Site Plan Review Committee (SPRC) Online Engagement Opportunity

Crystal Plaza 5 – 2250 Crystal Drive / 223 23rd Street S.

New Site Plan, and PDSP and Site Plan Amendments

223 23rd Street Building Deviations

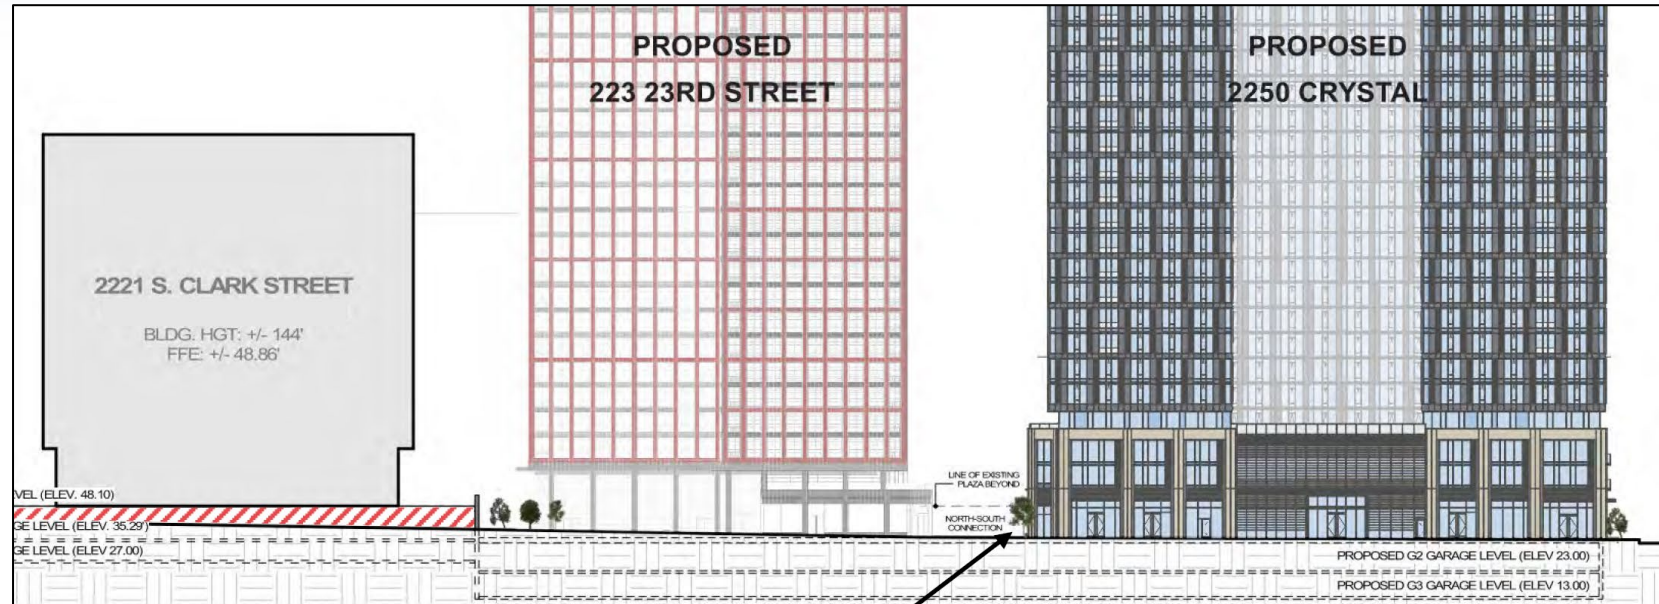
- Podium base defined through recessed space and canopy overhang
- Sector Plan calls for tower forming/sculpting with façade step backs

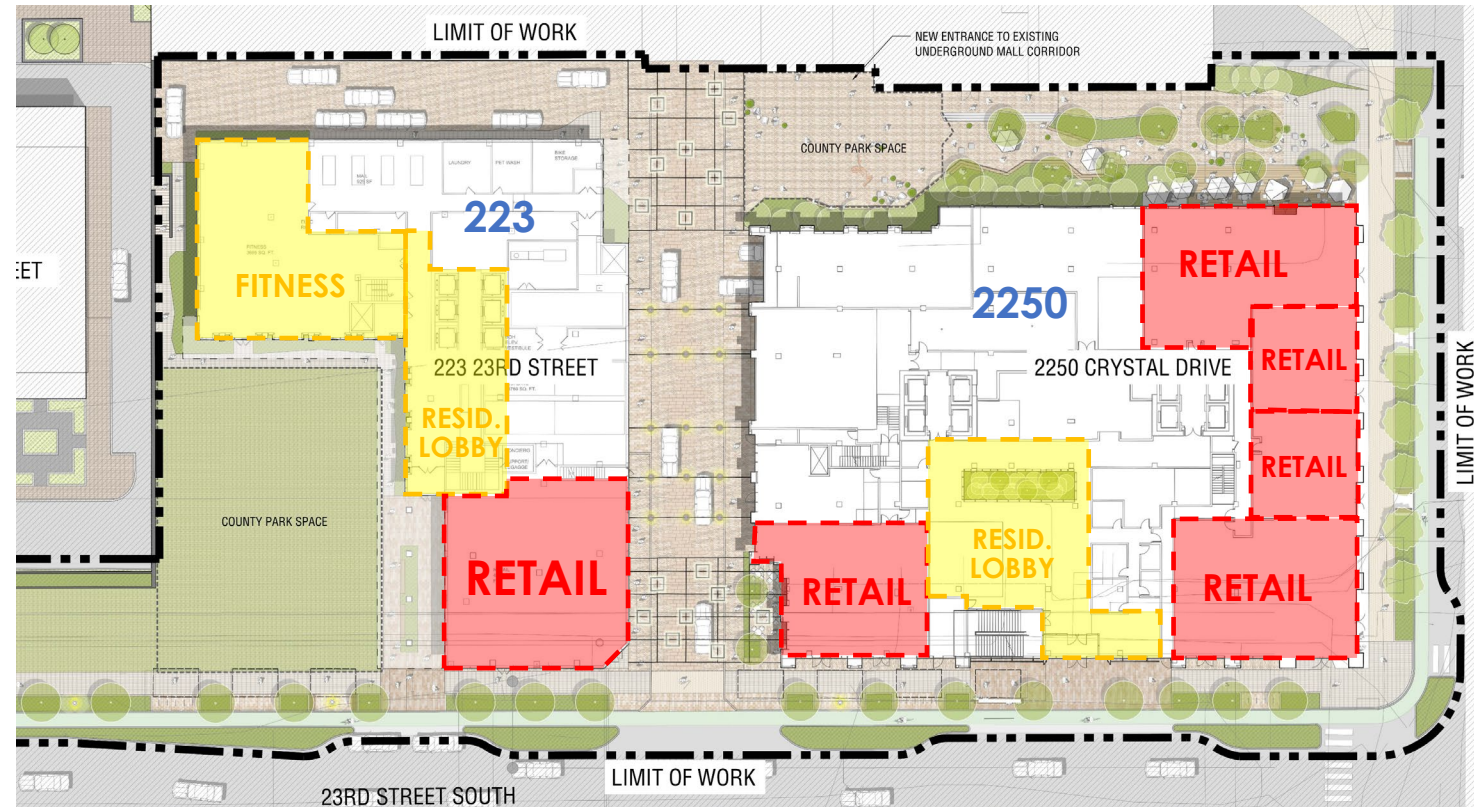
- At the North side of park #10, the applicant is proposing to have the **fitness space and lobby** as opposed to retail.
- **1/3 portion of the South façade** of building #3 is being proposed as staircase and lobby entrance to the residential building.
- The 2 facades facing Open Space #10 are identified in the Sector Plan as **Coordinated Frontage**.

NEW SERVICE ALLEY
"North-South Connection"

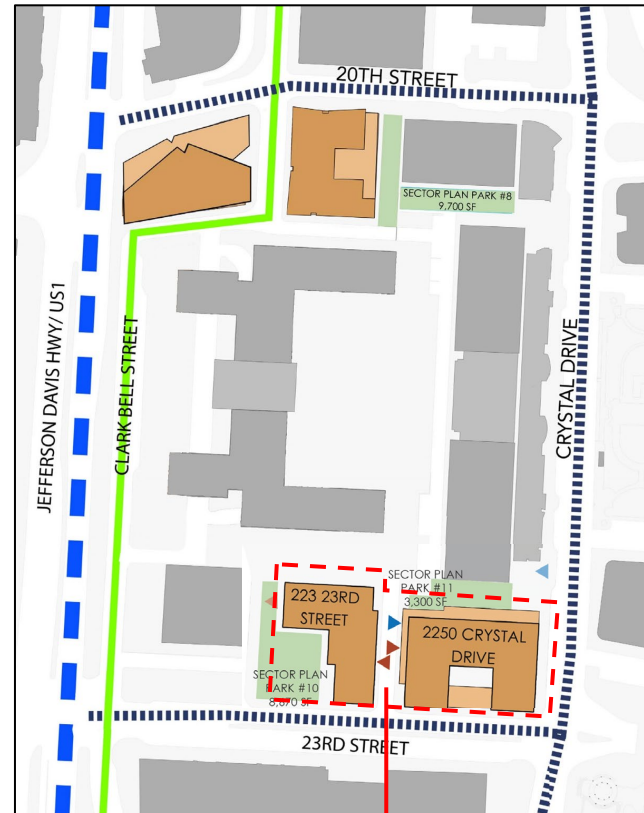
- A **North-South Connection** between the two buildings is proposed
 - Connection would remain as a dead end until further development happens to the North
 - New connection would result in new built-to-lines
- The Sector Plan envisions the service and loading entrances on the rear street parallel to 23rd Street
 - Proposed parking and loading entrances are located on the North-South Connection
- Parking is located in rebuilt garage structure connecting to existing underground parking area:
 - Proposed at 0.3 spaces/unit for both buildings
 - Residential Parking Guidelines (2017) recommend market rate parking ratio as low as 0.3 spaces/unit for this block

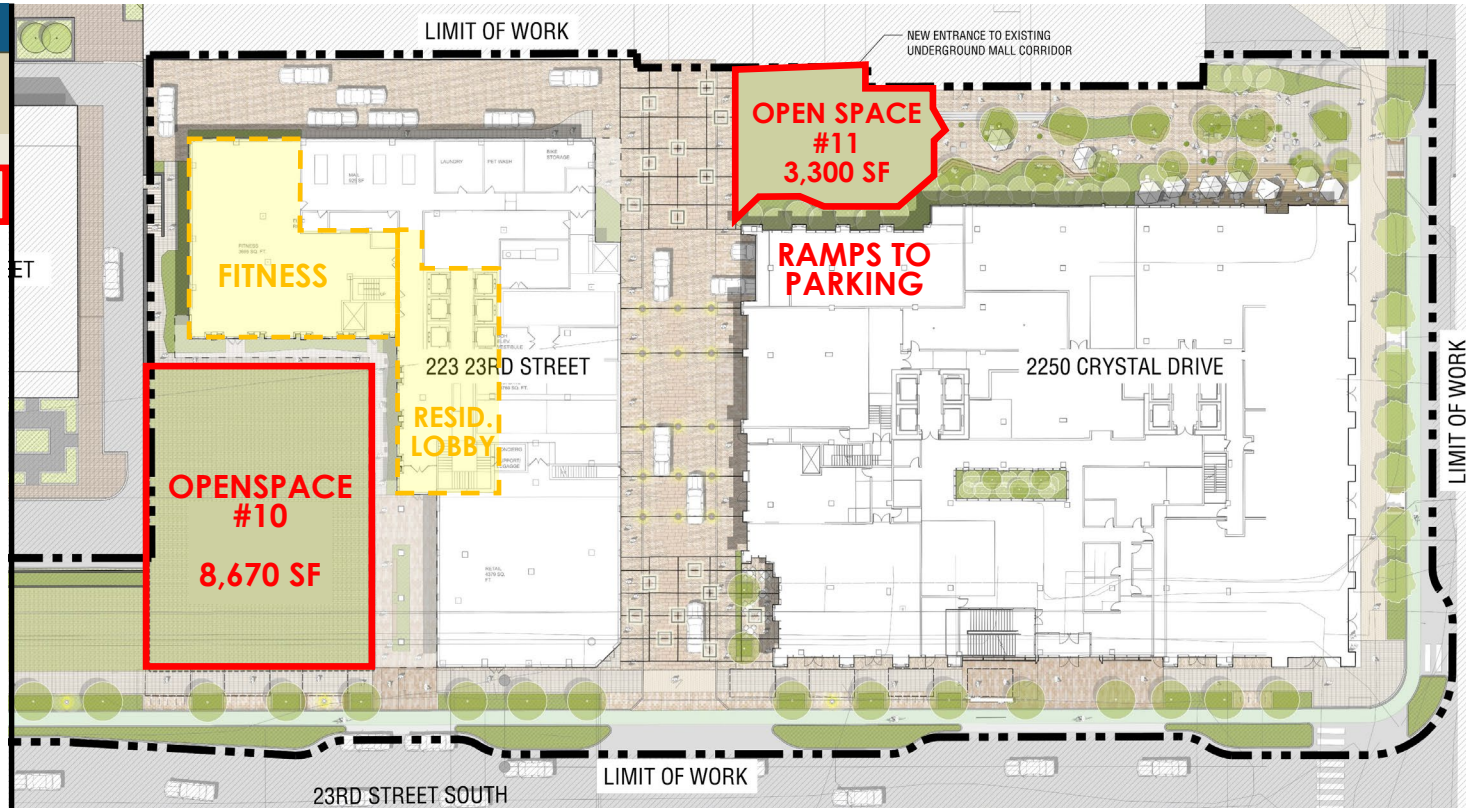
- The applicant is proposing an open space #10 that is **33% smaller** than what is envisioned in the Sector Plan as an interim condition.
- Space #11 is being shown in a **different location** and with different design elements.
- Both open spaces are framed by uses different than what the sector Plan is suggesting: **retail**.

Proposed access to the Underground

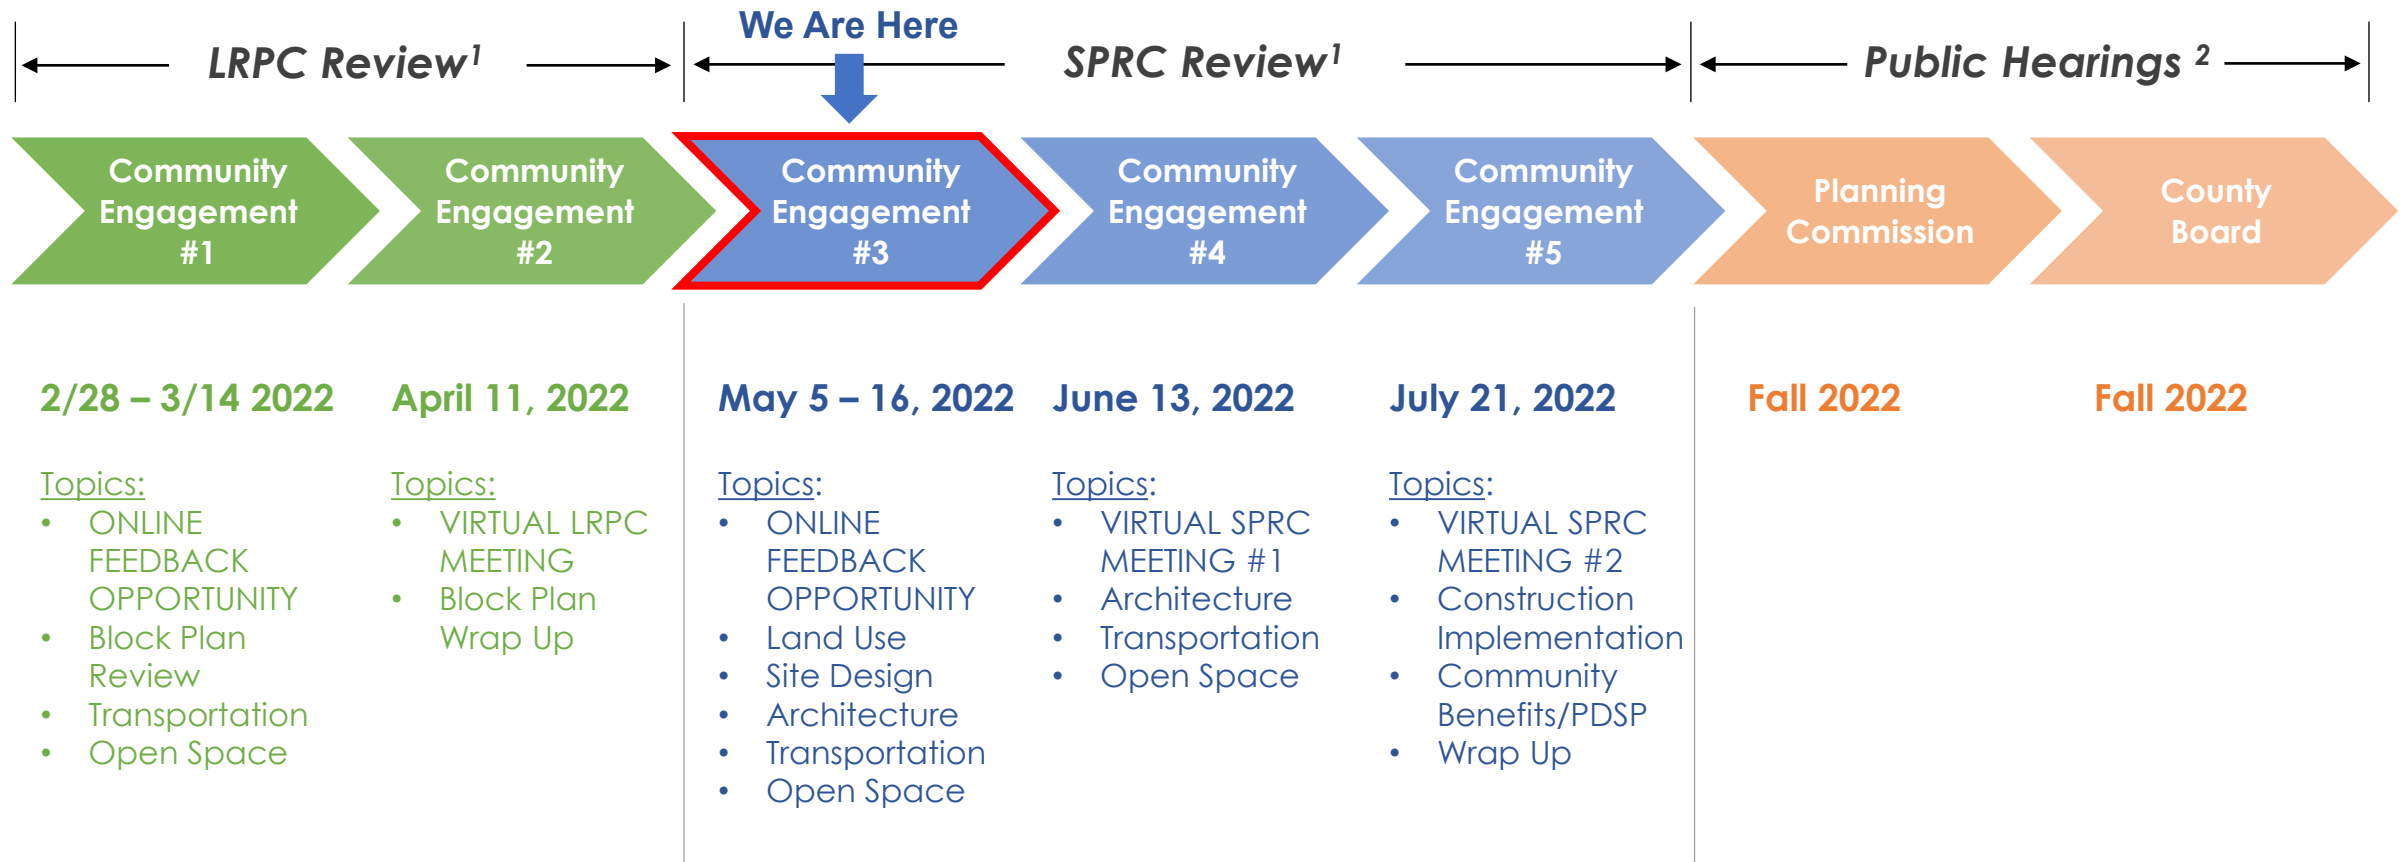
- Pedestrian access to the underground will be **provided along the sidewalk** of the new internal N/S connection.
- **Access to the underground** will be provided by the proposed open space #11.
